VOLUME 2 OF 2 - ZONING

# Summary of Comments on P:\Projects\1216-00\BIM\Revit \Families\TITLEBLOCKS\EXTELL Proposal\_atwalj.pdf

Summary of Comments on FP-401.00

## Summary of Comments on AAI-TWR-ARCHITECTURE- CANTILEVER\_namrudl.rvt

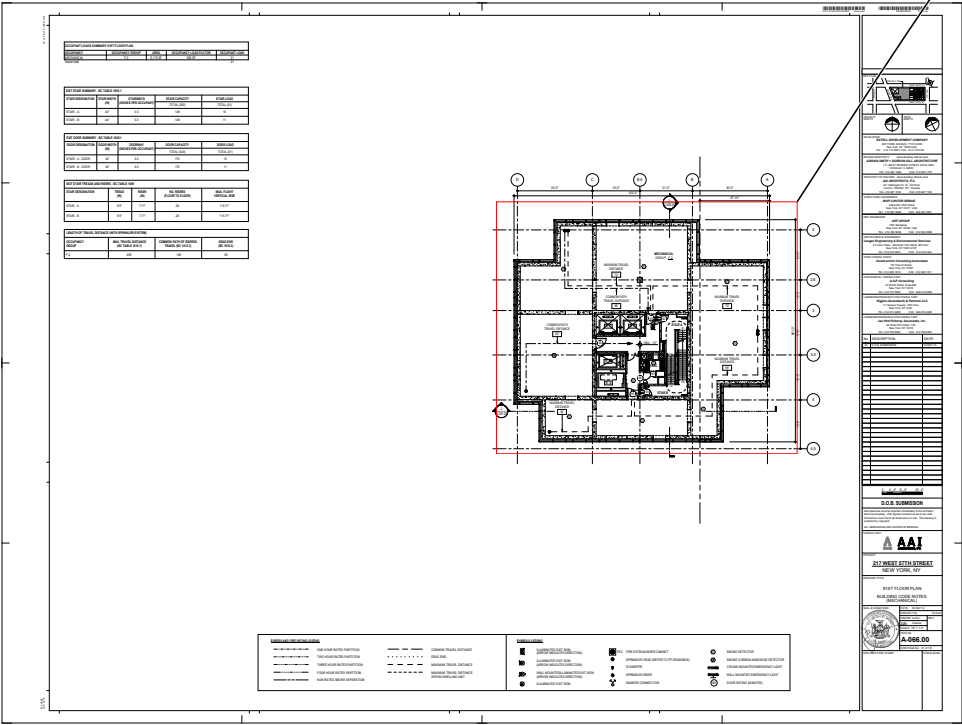
Author: dtitus Subject: Rectangle Date: 10/7/2014 9:24:08 AM  
Sufficient proof must be provided for entire fa deducted. Provide layout of heavy equipment for each floor in consideration to qualify for deductions.
